*Preliminary Consultation*  
**MONTGOMERY COUNTY HISTORIC PRESERVATION COMMISSION**  
**STAFF REPORT**

<b>Address:</b>	9832 & 9838 Capitol View Ave., Silver Spring	<b>Meeting Date:</b>	2/2/2022
<b>Resource:</b>	Spatial (undeveloped) <b>Capitol View Park Historic District</b>	<b>Report Date:</b>	1/26/2022
<b>Applicant:</b>	Mark Kaufman (Doug Mader, Architect; Phillip Long, Engineer)	<b>Public Notice:</b>	1/19/2022
<b>Review:</b>	Preliminary Consultation	<b>Staff:</b>	Dan Bruechert
<b>Proposal:</b>	Construction of two new single-family dwellings, tree clearing, hardscape, and associated sitework

**STAFF RECOMMENDATION**

Staff recommends the applicant make revisions based on the HPC’s feedback and return for a HAWP

**STREETSCAPE PLAN AND ELEVATION**

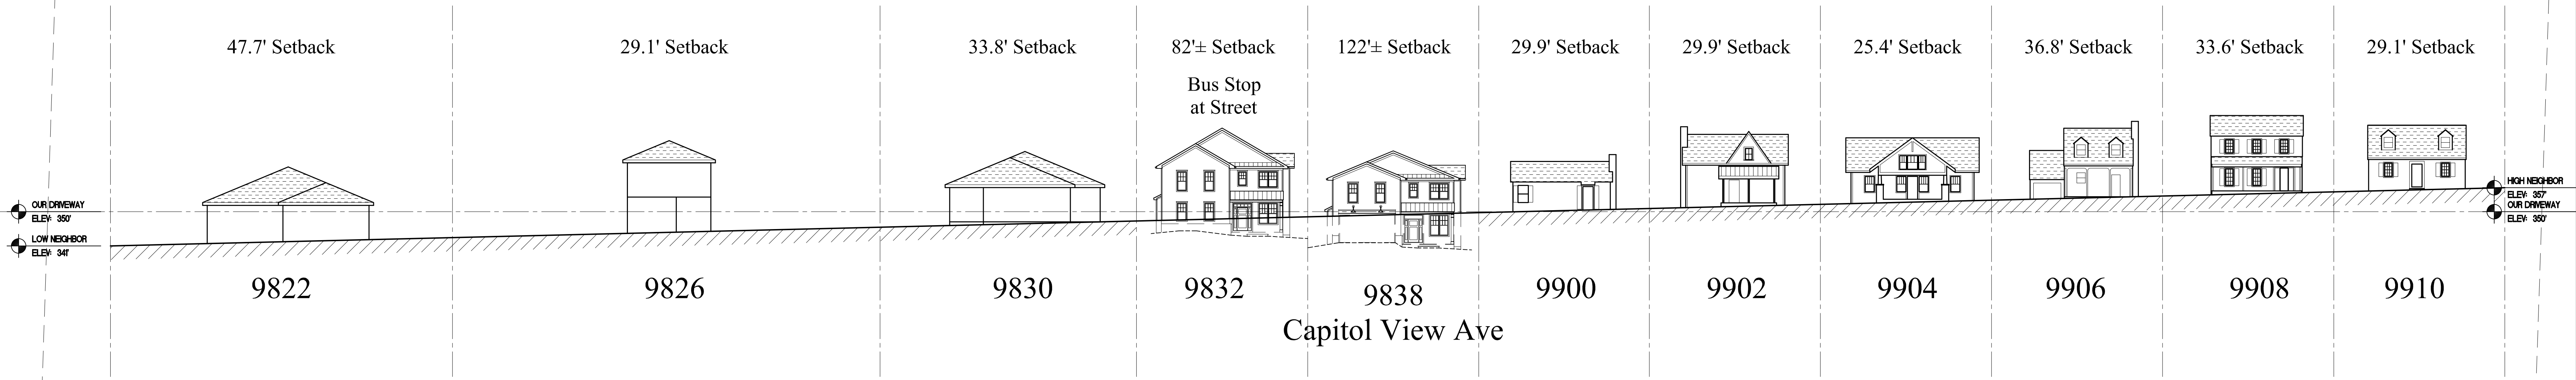
Both house designs are largely identical, so the Staff Report will discuss the houses in a single section. Both houses are two-stories and the main block of the house is approximately 35' × 40' (thirty-five feet wide by forty feet deep). Both houses also propose front telescoping, two-car garages that are approximately 20' × 30' (twenty feet wide by thirty feet deep), This limits side setback to approximately 7' 6" (seven feet, six inches), excluding projecting bays. The proposed houses are two stories tall, whereas most of the surrounding houses are one or one-and-a-half-story tall, though that may not have a significant impact on the streetscape because of the significant change in grade and deep setback. Staff also finds that the proposed houses appear slightly wider than many of the neighboring houses on the west side of Capitol View Ave., but not to the extent that they detract from the surrounding streetscape (see attached streetscape study).

The proposed house placement will not reinforce the existing settlement pattern along Capitol View Ave.

The front of the proposed house on Lot 12 will be set back 122' 4" (one hundred twenty-two feet and four inches). This location is rear of the property line of many of the other properties along Capitol View Ave. Due to the change in topography, the whole first floor of the proposed house is below the grade of Capitol View Ave. Staff finds that this location is far enough from the street that it will not have a significant impact on the surrounding district and that a lenient level of review should be applied (24A-8(d)). Staff also finds that the site limitations require any new house to be constructed in the approximate location proposed, and there would be no benefit to the surrounding district to move the house further to the west.

The proposed house at Lot 13 is setback 82' 8" (eighty-two feet, eight inches) from the street. This placement was selected to utilize the single driveway to accommodate parking in the side-loading garage at the front. The change in grade is not as significant at this location, so the proposed house looks much taller than the house on Lot 12. Based on Staff's analysis, a house on this lot could be in two possible locations, and each has potential benefits and drawbacks. In considering the proposed location, Staff finds that the proposal could preserve the 'spatial' character of the site in front of the house and could accommodate additional planting and shade trees. No landscape plan was provided, so this concept would need to be further discussed and evaluated at the Preliminary Consultation hearing. The drawback to the proposed location is that the new house does not reinforce the existing settlement pattern along Capitol View Ave. If the house were to be relocated closer to the street, modifications to the design could place an attached garage to the rear of the house, solving an identified design issue discussed above. However, Staff finds a house closer to the street on this lot would visually compete with the bus stop shelter, and curb cut for the crosswalk which may not be compatible with the surrounding district.
